URBAN RENEWAL AGENCY MEETING PACKET

A. Hwy 99 Pedestrian Bridge Project (Craig Sheldon, Public Works Director)

Sherwood 99W Pedestrian Bridge Crossing Value Engineering Work Session City Council

Meeting Objective

East Approach: Delete Steel Plate Wall

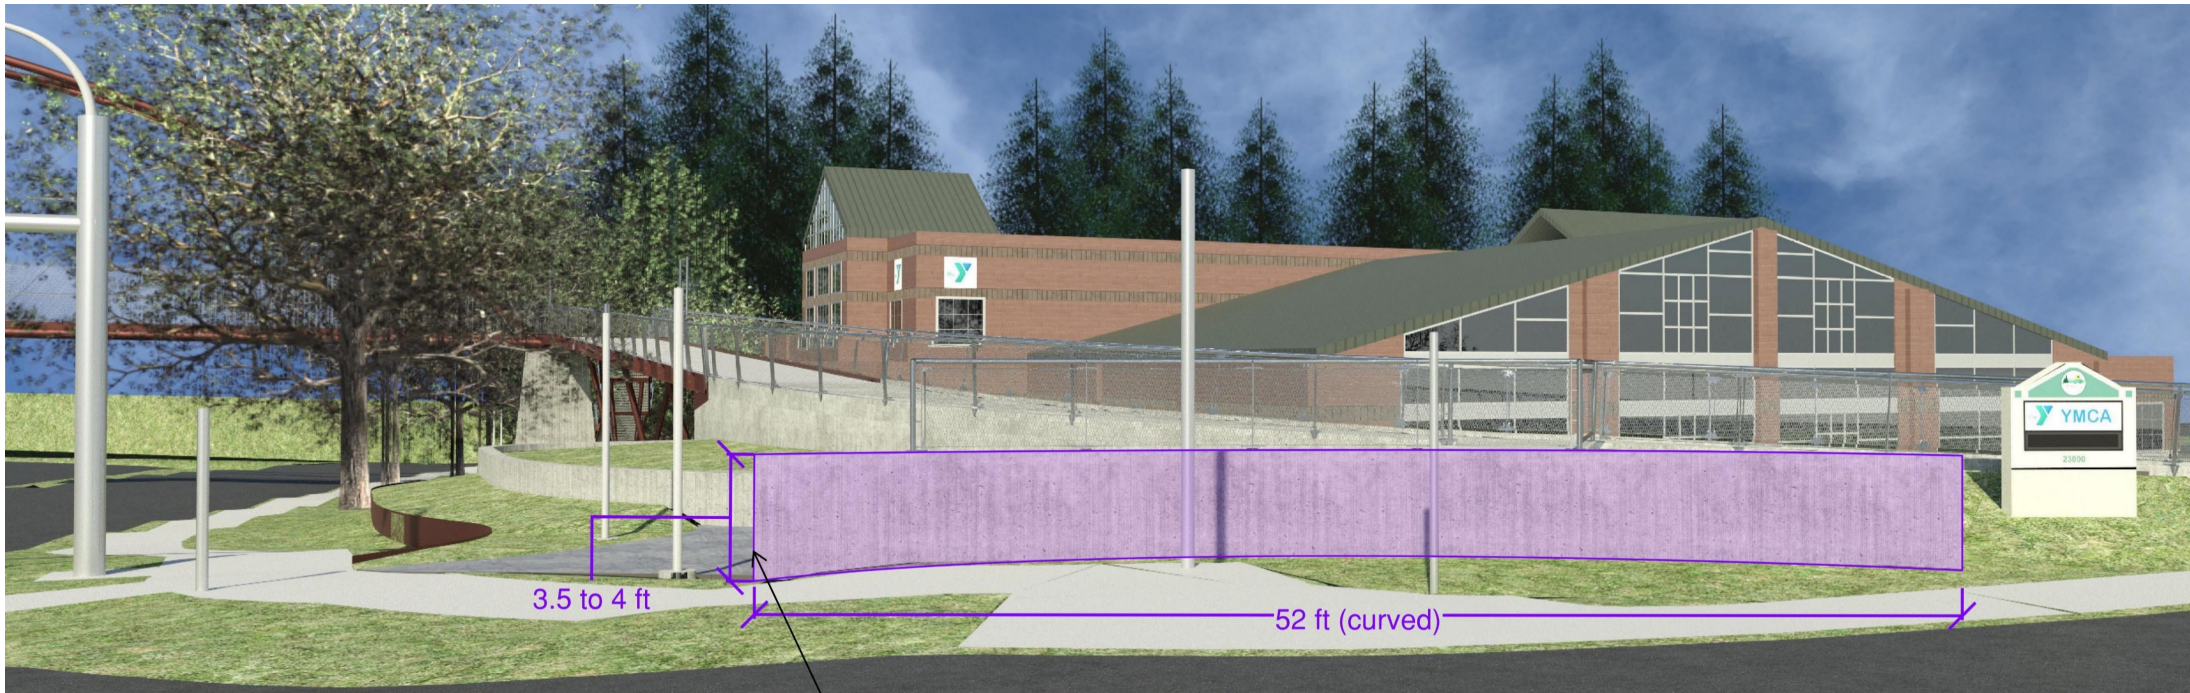
Current (w/ Steel Plate)

Revised (taller concrete wall)

Bridge Spans: Truss Stainless Steel Rods/Struts to Galvanized

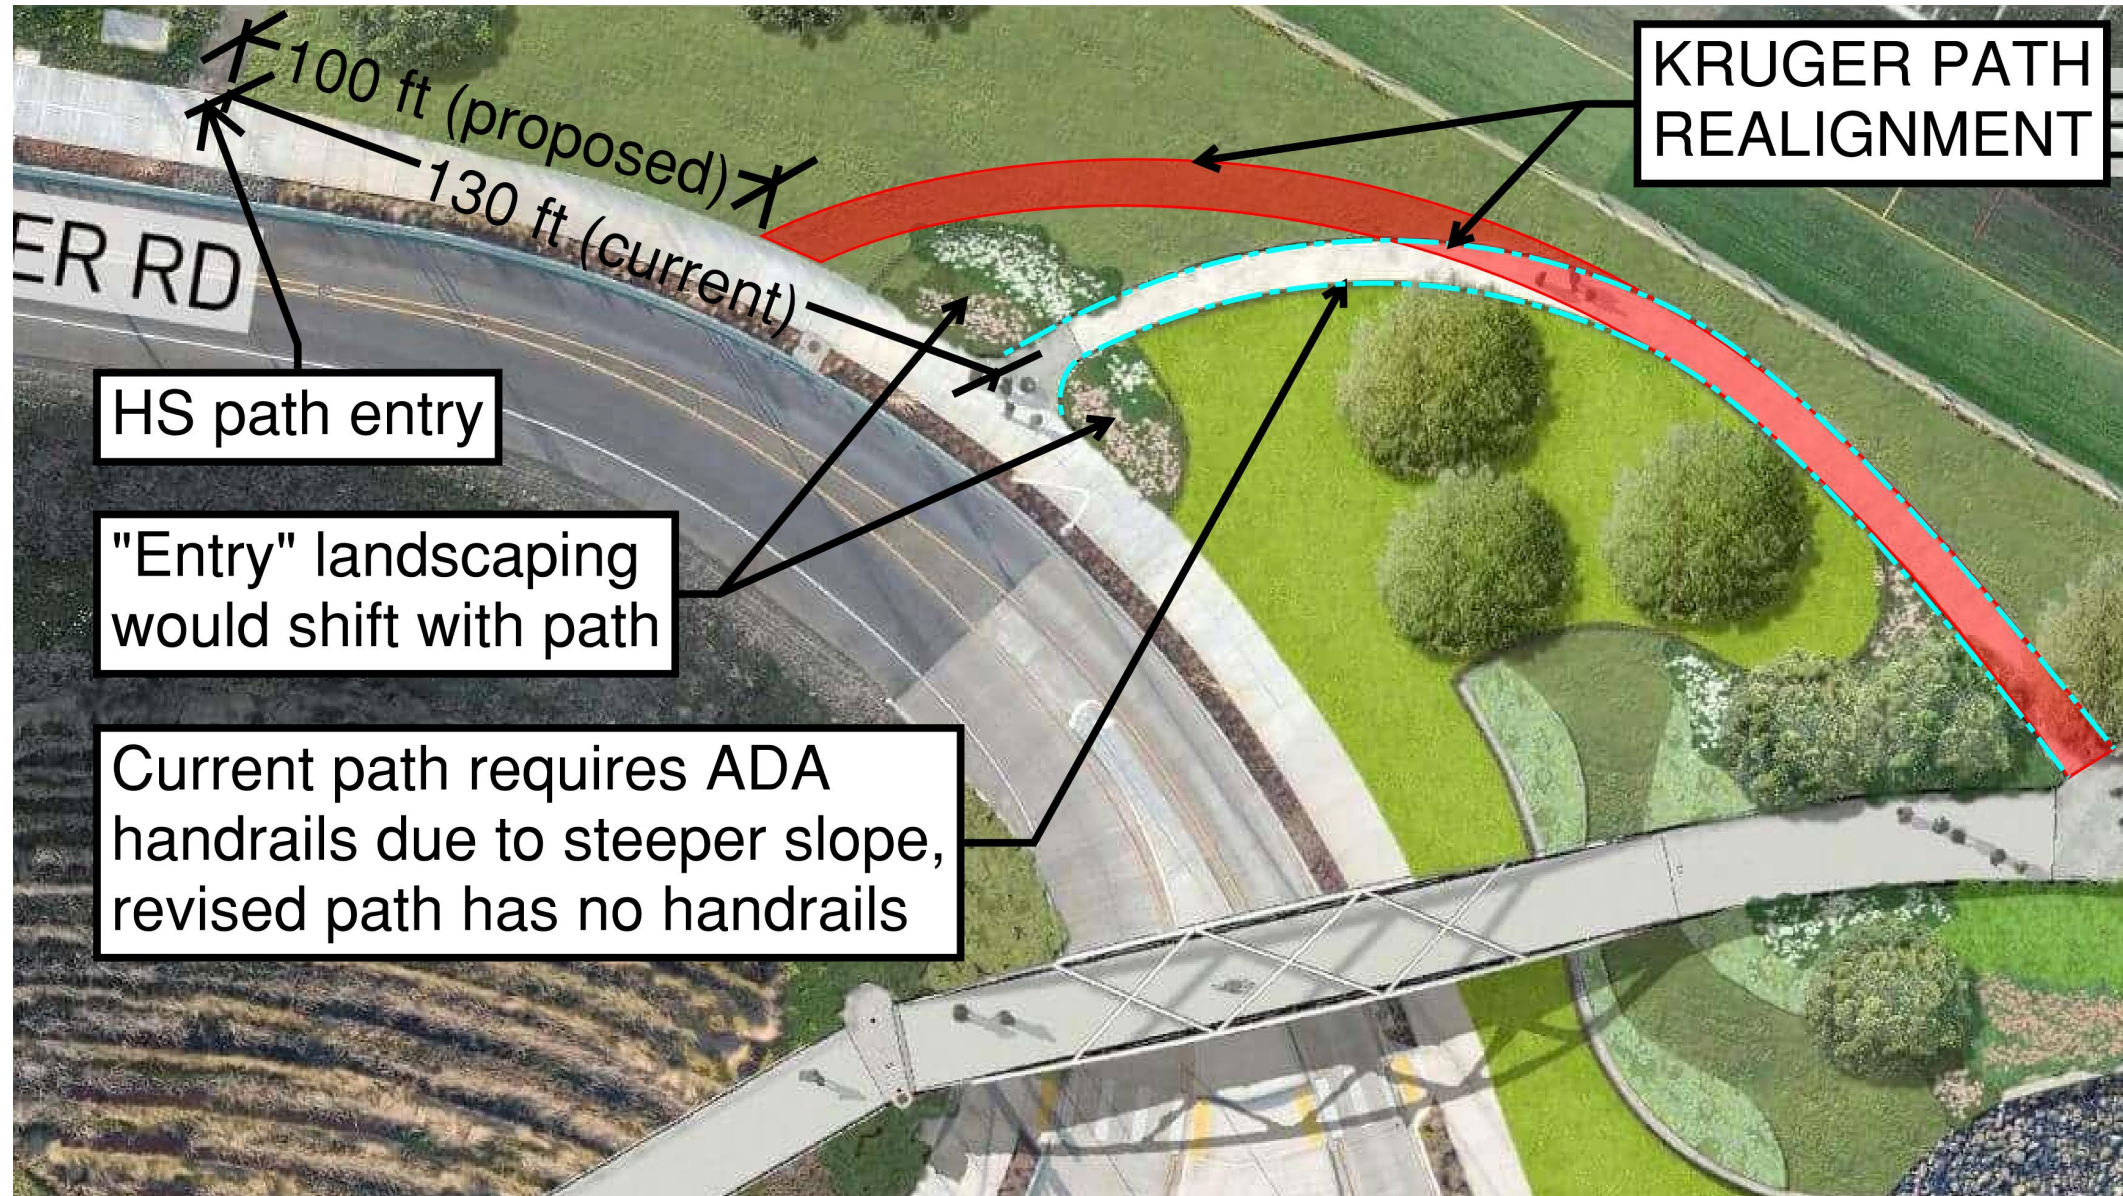
- A. Delete **steel plate wall** at east approach (**\$110 k to \$140 k**)
- B. Delete/defer **art wall lighting** at east approach (**\$10 k to \$20 k**)
- C. Stainless steel **truss rods/struts to galvanized** (**\$100 k to \$130 k**)
- D. Adjust **Kruger Path grading** to eliminate railings (**\$140 k to \$180 k**)
